Issue List

Citrus Cardiology (Crystal River, FL)

Project Issue Information

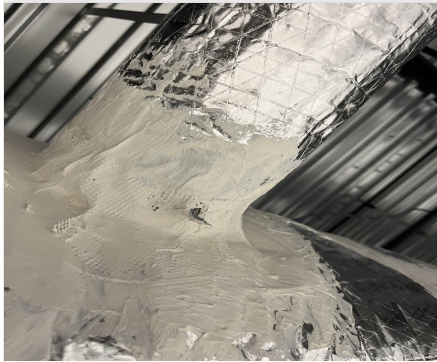
Issue Name : Damper Accessibility Room 103
Description : There are two supply ducts for FCU-11 located above Room 103 that do not appear to be accessible now that the ceiling grid is installed. The damper handles do not appear to be fully horizontal, suggesting they are not tightened down. These may move over time so we will need to figure out how to access them.

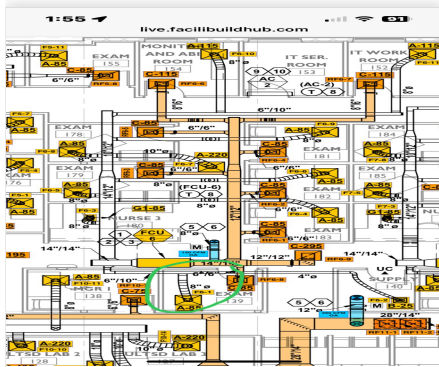
Issue Name : FCU 10 Missing Return Damper Room 126
Description : There is no damper installed on the return for FCU 10 in room 126. Due to the hard ceiling it would be best if a face-accessible damper is installed, or the damper is installed at the take-off.
Created By : National TAB **Assigned To :** National TAB - Stephen Tassinaro
Status : Open
Priority : Urgent **Asset Tag :**
Originated Date : 06/12/2025 - Stephen Tassinaro - National TAB

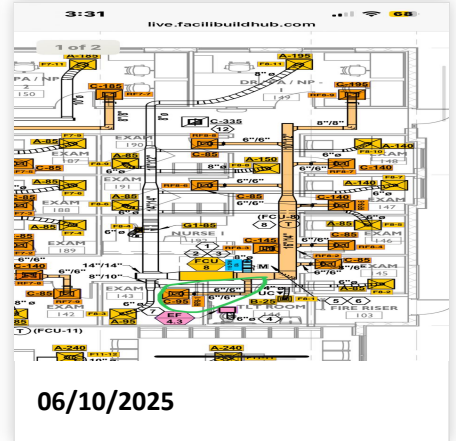
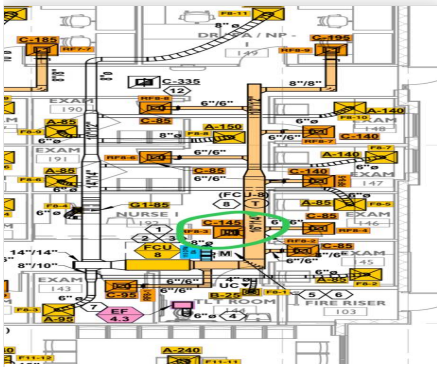
Issue Name : FCU 8 Return Damper 1 (143)
Description : Damper not located for FCU 8 return number 1, Exam 143. This damper is needed to balance the unit's return. Recommend installing damper.
Created By : National TAB **Assigned To :** National TAB - Stephen Tassinaro
Status : Open
Priority : Urgent **Asset Tag :**
Originated Date : 06/10/2025 - Kristopher Passley - National TAB

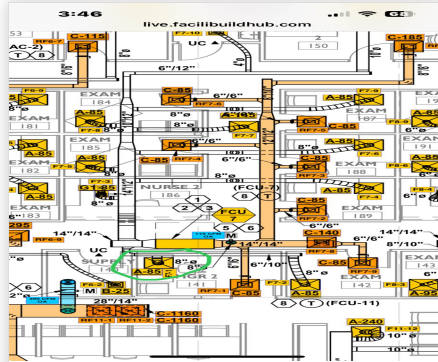
Issue Name : FCU-7 Diffuser 1 (141)
Description : FCU-1 Diffuser 1, MGR 2 (141), flex duct is not long enough to allow it to drop into ceiling grid.
Created By : National TAB **Assigned To :** National TAB - Stephen Tassinaro
Status : Open
Priority : Urgent **Asset Tag :**
Originated Date : 06/10/2025 - Kristopher Passley - National TAB
